PROPOSED S8.2 REVIEW FOR REFUSED DEVELOPMENT APPLICATION - DEMOLITION OF AN EXISTING HOUSE, CONSTRUCTION OF A NEW DWELLING WITH A SECONDARY DWELLING AND THREE PARKING SPACES

### **28 STUART STREET COLLAROY**

DA2021/2566

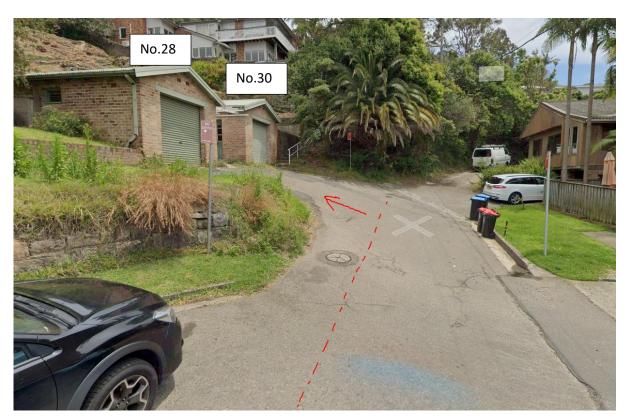
## 2. B3 Side Boundary Envelope of the Warringah DCP

An additional plan (drawing A302) has been prepared to confirm the compliance with Side Boundary Envelop requirements.
